January 3, 1990
LD-90-001Docket No. 70-36
License No. SNM-33

Subject: License Amendment Request

HEMATITE NUCLEAR FUEL MANUFACTURING FACILITY

REQUEST FOR LICENSE AMENDMENT

FIGURE II.8.3-7
EFFECTIVE MULTIPLICATION FACTOR vs. WATER DENSITY
INFINITE CHECKERBOARD ARRAY OF UO₂ AND WATER CONTAINERS

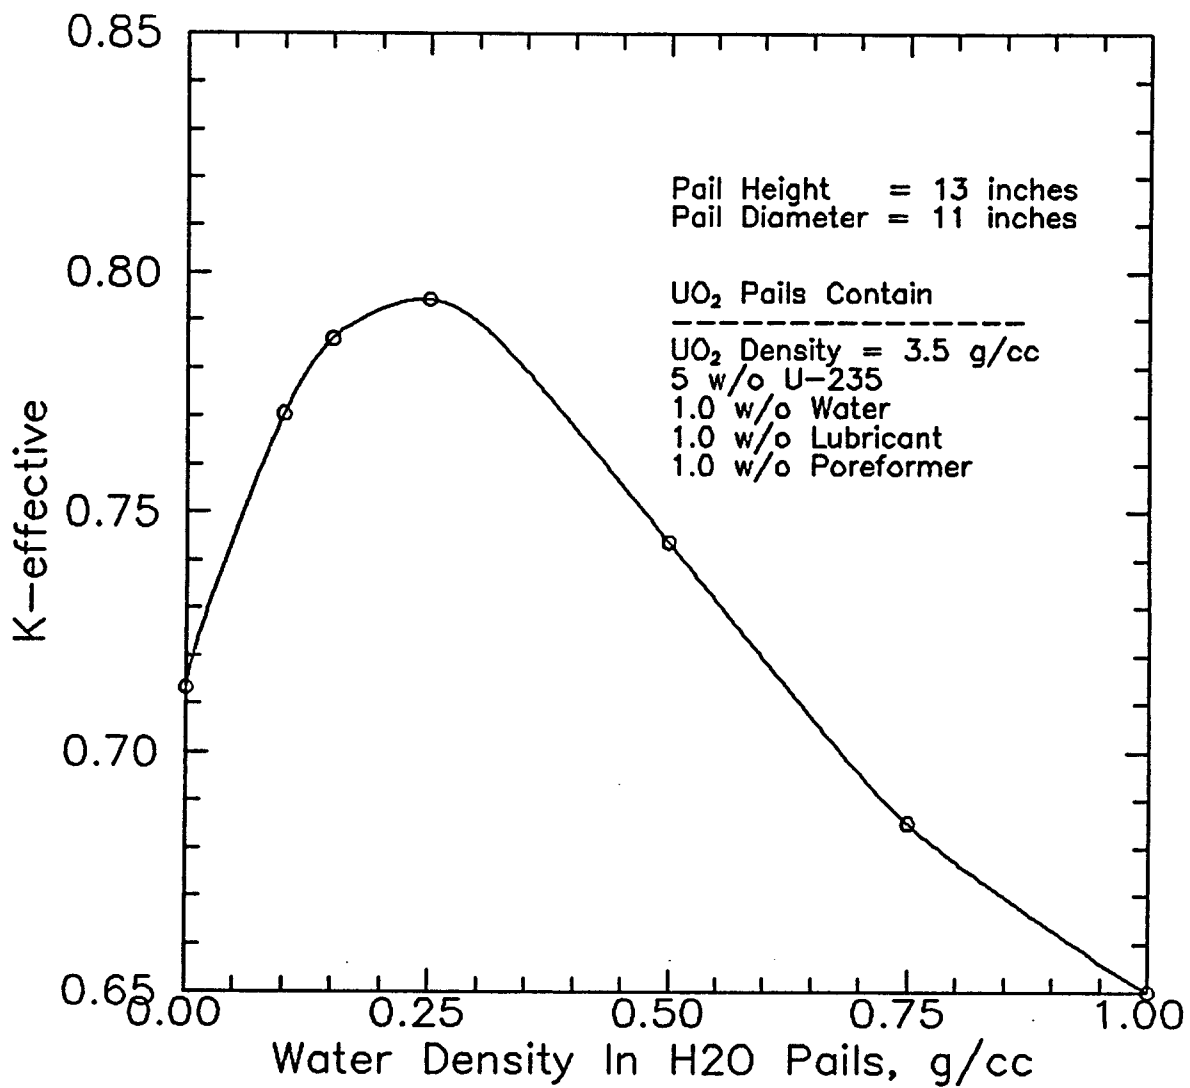
KENO was used with the 16 group Hanson and Roach library and with the generalized geometry option to describe 4 quarter cylinders in contact with each other in a square array. Figure II.8.3-7 shows the effective multiplication factor as a function of water density in the water containers. The maximum value is less than 0.8 and occurs at a water density of 0.25 g/cc. The moderating properties of the poreformer and lubricant are encompassed by the range of water densities analyzed. Therefore, the above analyses confirm that the criticality criterion is satisfied for any combination of SNM, mop water, poreformer, and lubricant containers within the limits imposed by Section I.4.2.3.q.

FIGURE II.8.3-9
EFFECTIVE MULTIPLICATION FACTOR FOR AN ISOLATED MIXER
WITH 100 Kg UO₂ POWDER vs. POREFORMER LOADING

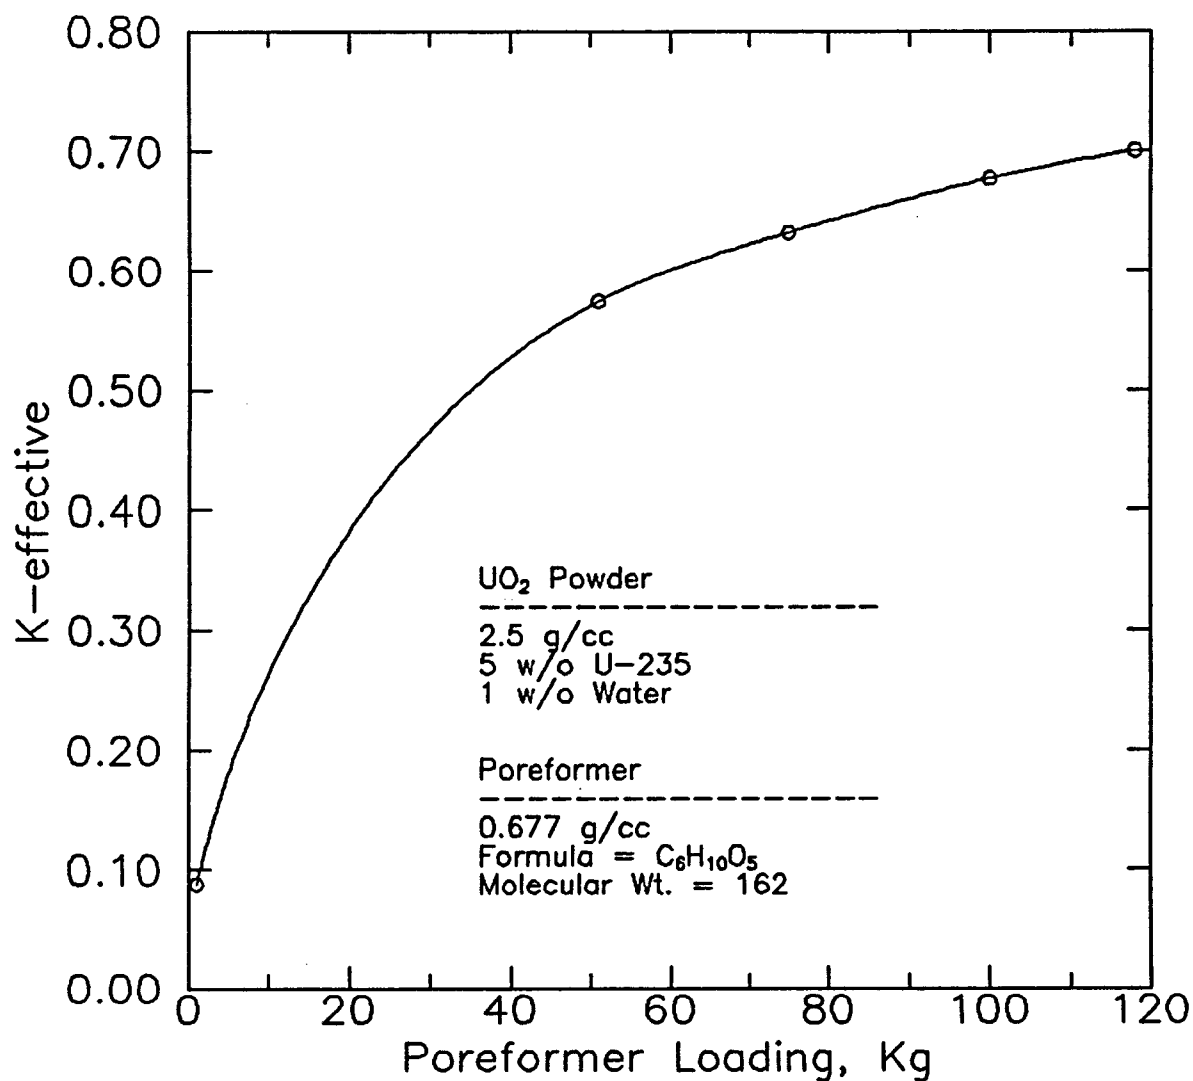
Two situations were analyzed. In the first, a typical sized batch of 100 Kg of UO_2 powder is in the mixer and poreformer is added. Typically the poreformer is 0.15 to 0.25 w/o of the UO_2 , or about 0.2 Kg per batch. At about 21 Kg poreformer the UO_2 voids are filled. Thereafter, the mixture volume increases with added poreformer until the mixer is filled at 118 Kg of poreformer. Table II.8.3-3 and Figure II.8.3-9 show the results. The effective multiplication factor increases with poreformer to a maximum value of 0.70 when the mixer is full.

FIGURE II.8.3-10
EFFECTIVE MULTIPLICATION FACTOR FOR AN ISOLATED MIXER
FILLED WITH UO_2 POWDER AND POREFORMER

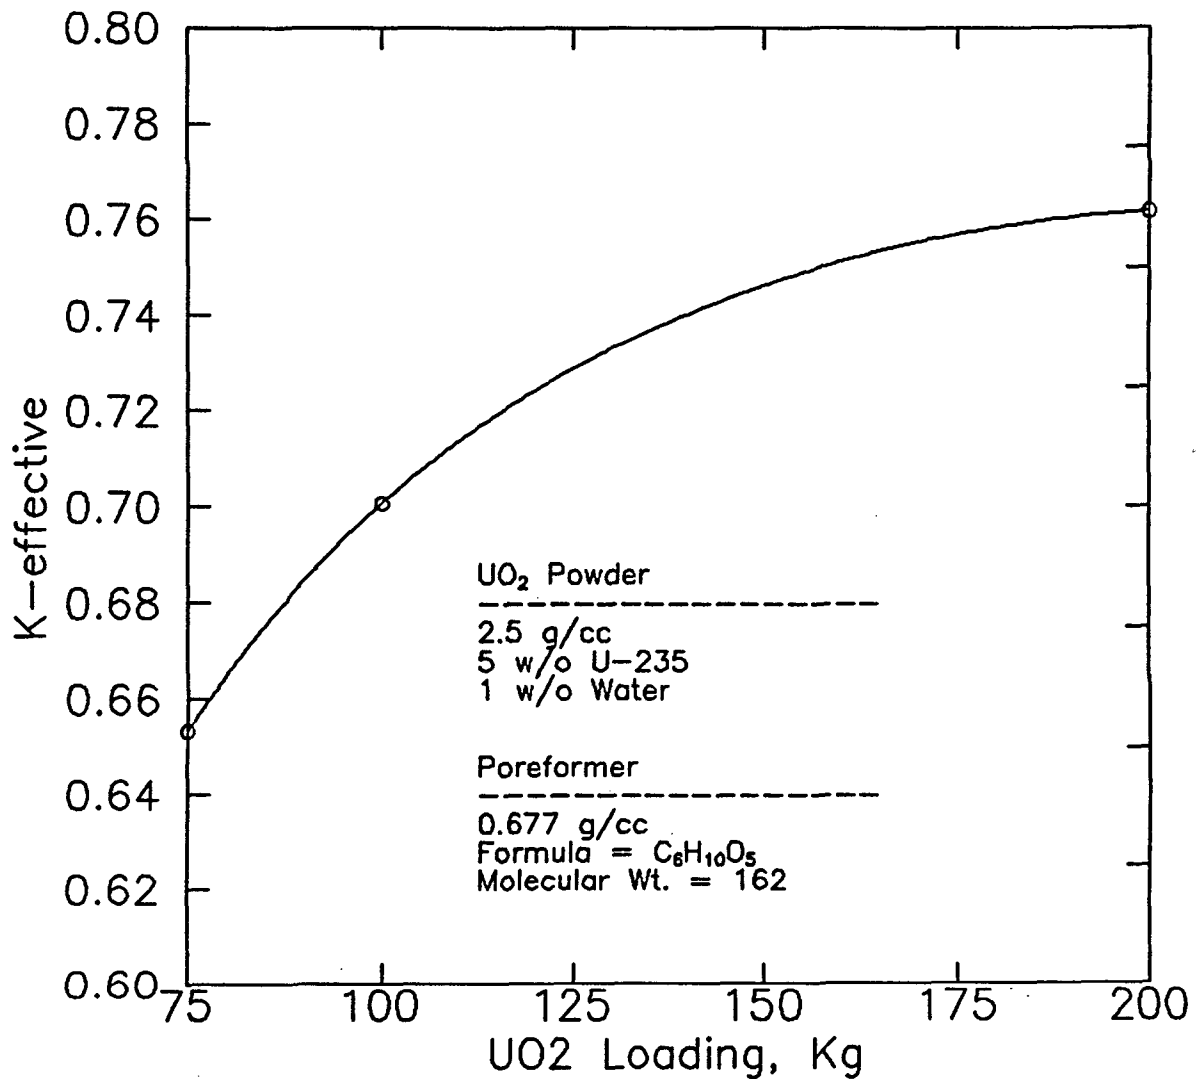
In the second situation analyzed, the mixer is assumed filled. Three selected mixtures of UO_2 powder and poreformer are analyzed. The UO_2 loading is varied from 75 Kg to 200 Kg while the poreformer loading varies from 119.5 Kg to 111.8 Kg to maintain a constant, full mixer volume. The effective multiplication factor increases with UO_2 loading to 0.76 at 200 Kg UO_2 - twice the normal UO_2 loading. Table II.8.3-4 and Figure II.8.3-10 show these results.

FIGURE II.8.3-11
KENO MODEL FOR FRONT-END OF DETAILED PELLET LINE
(FOR GENERALIZED GEOMETRY OPTION)

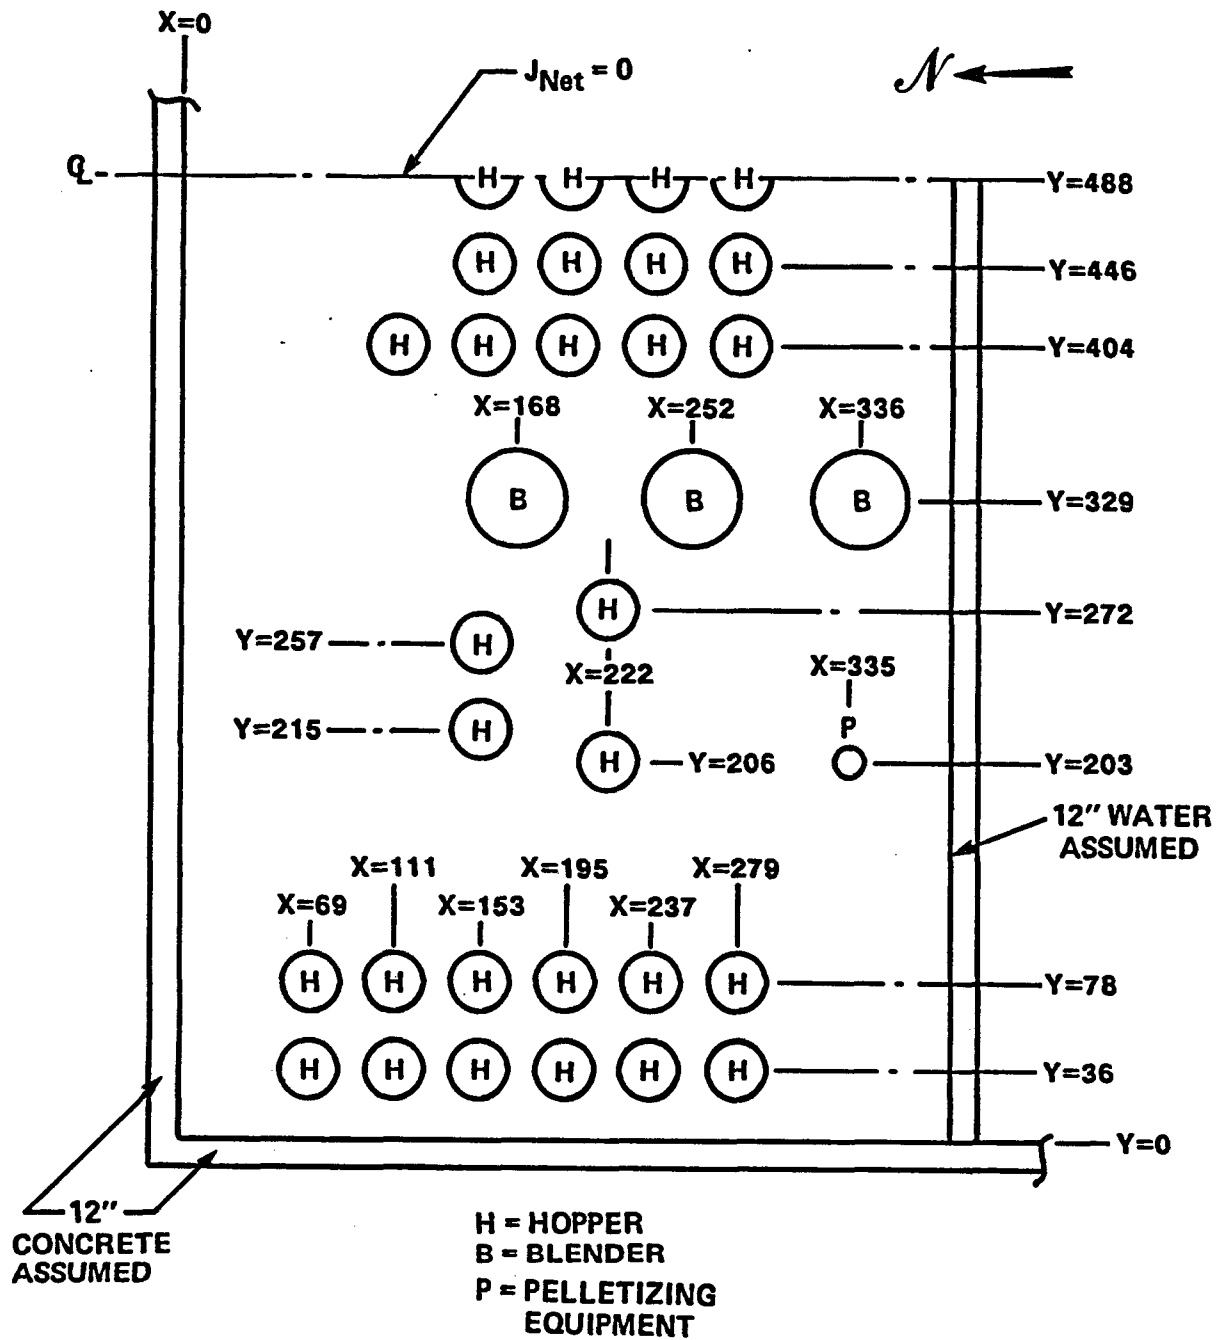
- a) The bulk storage hoppers contain 1000 Kg UO_2 and the blenders contain 4200 Kg UO_2 . They all have 3.5 g/cc UO_2 density, 5 w/o U-235 and 1 w/o water.
- b) The pelletizing line components contain a mixture of UO_2 and poreformer in the proportions 100 Kg UO_2 to 118 Kg poreformer, which is the mixture that produced the maximum k-effective for an isolated poreformer mixer. Structural materials are not modeled here. (Previously the steel walls of the isolated poreformer mixer were modeled.)
- c) The system is reflected on top with 12 inches of water, on bottom with 12 inches of concrete, on the west and north by 12 inches of concrete and on the south by 12 inches of water (see Figure II.8.3-11).

KENO was used with 16 group Hanson and Roach library and with the generalized geometry option. Figure II.8.3-11 shows a plan view of the overall arrangement. Figure II.8.3-12 shows the model for the bulk storage hoppers and Figure II.8.3-5 shows the model for the blenders. Figure II.8.3-13 shows the detailed model for the vertical arrangement of components of the pelletizing equipment that may contain significant volumes of UO_2 .

FIGURE II.8.3-13
KENO MODEL FOR PELLETIZING LINE
(FOR GENERALIZED GEOMETRY OPTION)

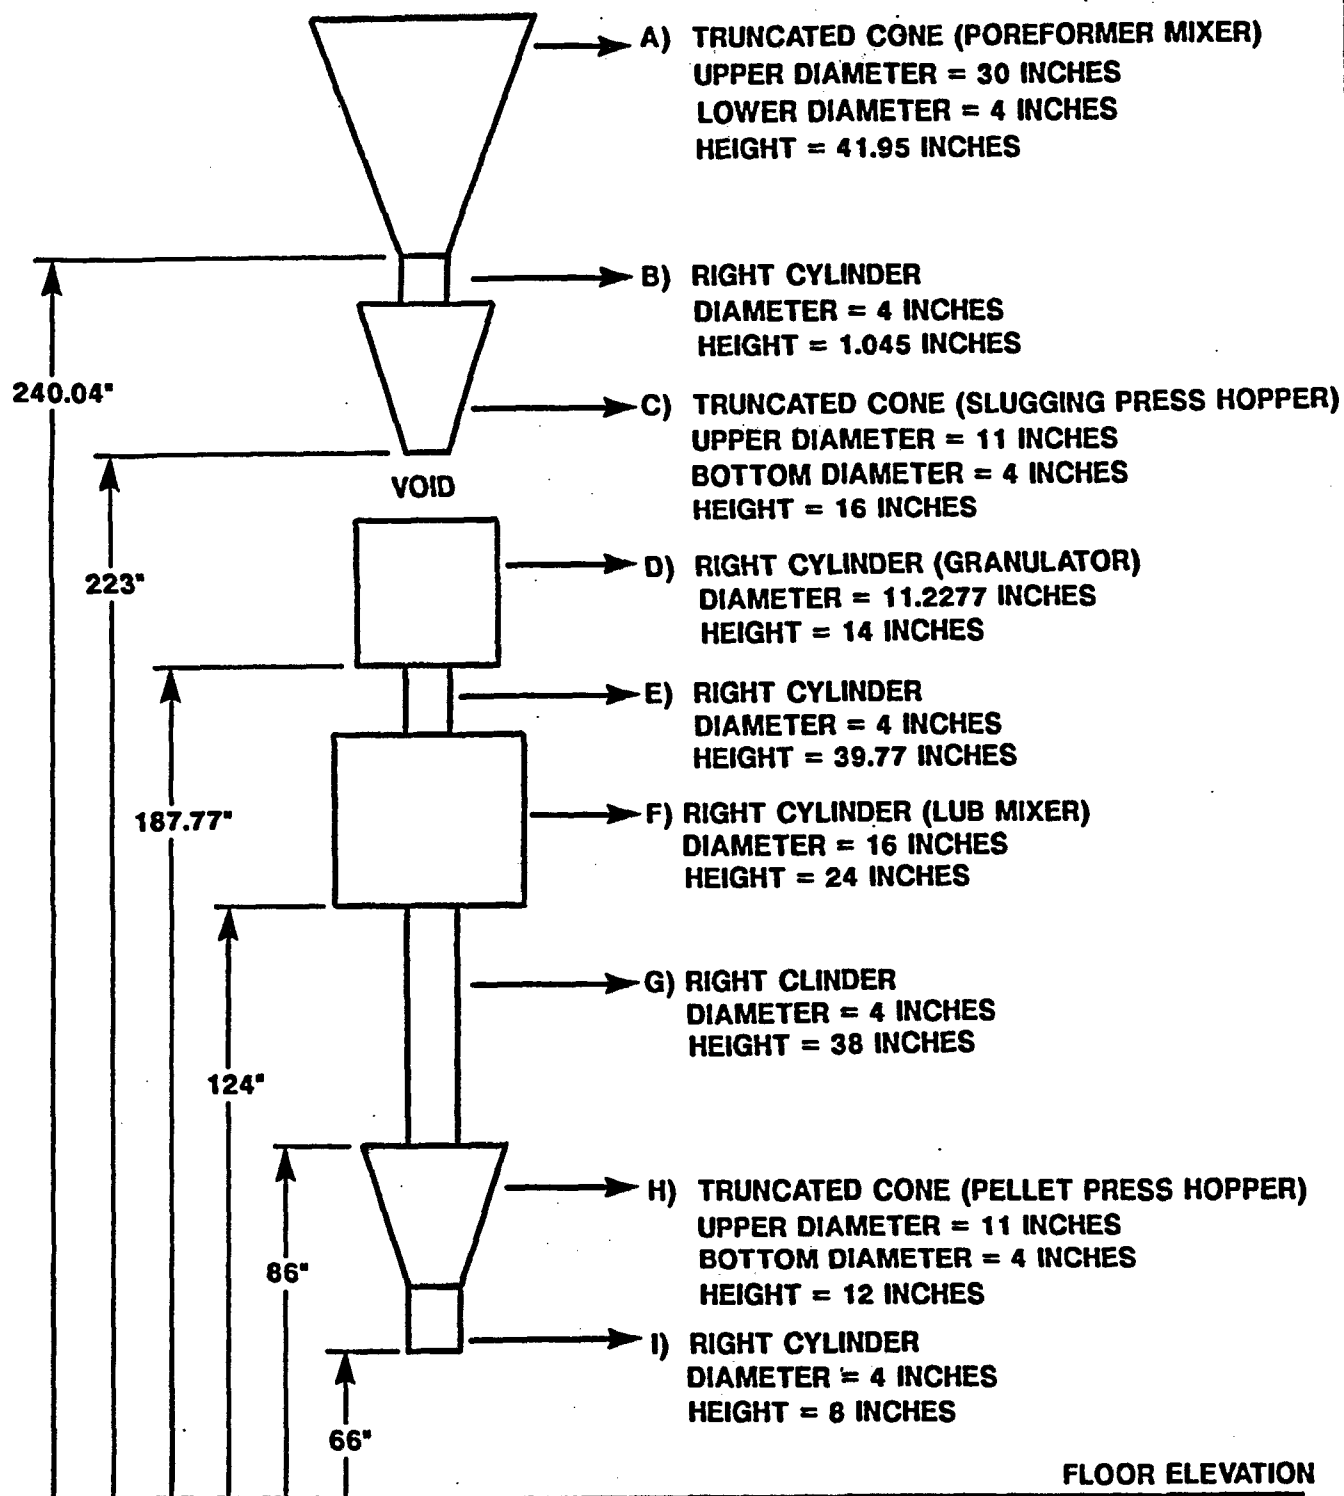
Table II.8.3-5 contains KENO calculated eigenvalues for several different situations. In the first case an isolated conical screw mixer was simulated. (This mixer is labeled "A" in Figure II.8.3-13.) In the second case all of the hoppers, blenders, and the conical screw mixer were simulated. In the last case the hoppers, blenders and all of the described pelletizing line were simulated. As indicated by these results, there is very little interaction between the mixer or

the entire pelletizing line and the hoppers and blenders. Also indicated is that the eigenvalues for this system are far below the safe limit of 0.95 even with the conical mixer filled with 118 kilograms of poreformer.
